Staff Report to the Planning Commission

Application Number: **131027**

Project Description: Proposal to demolish one dwelling (on a site with two existing units) and construct one duplex and one triplex (five new multi-family units) for a total of six units in the RM-3 zone district.

Location: Property located on the west side of 17th Avenue, approximately 75 feet north of the intersection of Merrill Street and 17th Avenue (721 17th Avenue).

CLIENT: WILLIAM BLACK	 ROPER ENGINEERING CIVIL ENGINEERING & LAND SURVEYING 64 PENNY LANE, SUITE A WATSONVILLE, CA 95076 (831) 724-5300	JOB NO.: 12047
LOCATION: 100 SANTA MARIA PL		DATE: JULY 8, 2013
DRAINAGE CALCS		SHEET: 4 OF 8

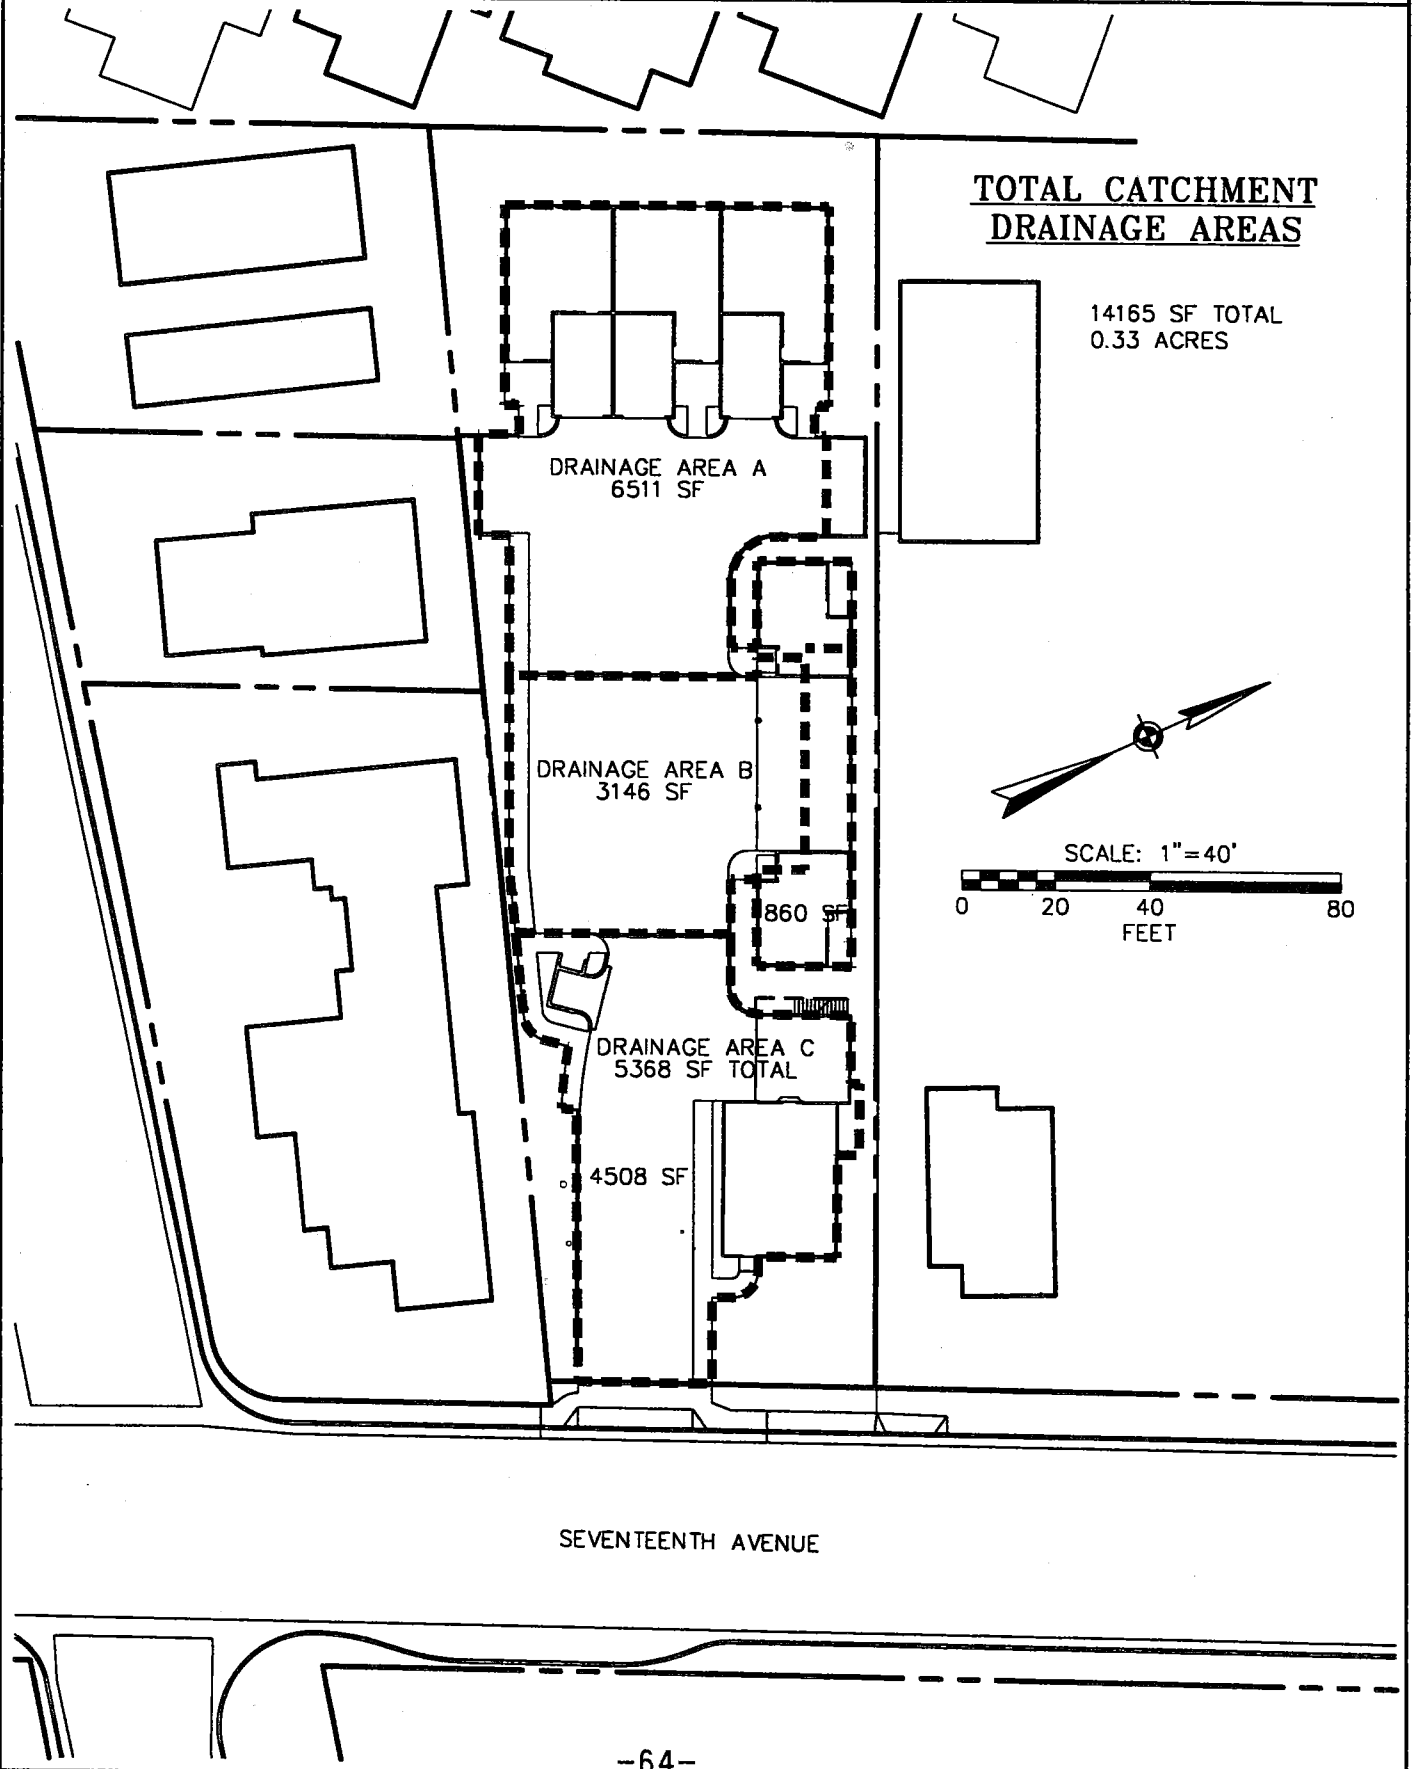
- d. A concrete cutoff wall is required for pond C (see Exhibit G, Drainage Study, sheet 4 of 8) to prevent saturation of the sidewalk and roadway sub base.

4. A concrete cutoff wall is required for pond C to prevent saturation of the sidewalk and road way sub base.
5. Please provide cross section construction details for the proposed permeable pavers, under sidewalk drains, graded swales, and concrete cutoff walls.
